# Access Compliance Report

## Public Rights-of-Way

### (Curb Ramps)

Intersection ID: 15178	Main Street: DILWORTH_RD_EAST	Cross Street: IDEAL_WY	Location: NW
ADA ID: 4EFB65C14BBD	Ramp Type: PerpDiag	Initial Pass/Fail: Fail	Overall Compliance: No
Severity Score: 12.5			
Codes/Mitigation Info/Possible Solution		Field Measurements/Component Compliance

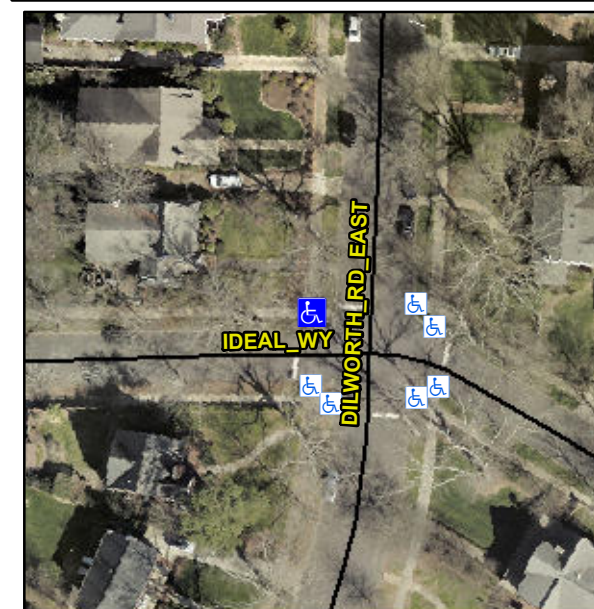
**Not Found, R304.5.3**

Compliance	Description	Data	Compliance	Description	Data
N/A	Ramp Length (in)	72.0	Yes	Ramp Slope (%)	6.9
Yes	Ramp Width (in)	72.0	No	Ramp XSlope (%)	5.5
N/A	Flare Type LT	N/A	N/A	Flare Type RT	N/A
N/A	Flare Slope LT (%)	N/A	N/A	Flare Slope RT (%)	N/A
N/A	Flare Traversable LT?	N/A	N/A	Flare Traversable RT?	N/A
N/A	Landing Length (in)	N/A	N/A	DWS Provided?	N/A
N/A	Landing Width (in)	N/A	N/A	DWS Contrast?	N/A
N/A	Landing Slope (%)	N/A	N/A	DWS Length (in)	N/A
N/A	Landing X Slope (%)	N/A	N/A	DWS Full Width?	N/A
N/A	Landing Curb? (Y/N)	N/A	N/A	DWS Offset (in)	N/A
N/A	Shared Landing?	N/A			
N/A	Gutter Ponding?	N/A	N/A	Gutter Slope (%)	N/A
N/A	Gutter Lip Ht (in)	N/A	N/A	Gutter X Slope (%)	N/A
N/A	Painted X Walk1?	No	N/A	Painted X Walk2?	No
	X Walk 1 Direction	To S		X Walk 2 Direction	To E
N/A	X Walk 1 Width (in)	N/A	N/A	X Walk 2 Width (in)	N/A
	X Walk 1 Slope (%)	3.8		X Walk 2 Slope (%)	3.7
	X Walk 1 X Slope (%)	0.7		X Walk 2 X Slope (%)	2.9

**Remove & Replace Curb Ramp With Two New Directional Ramps or Equivalent.**
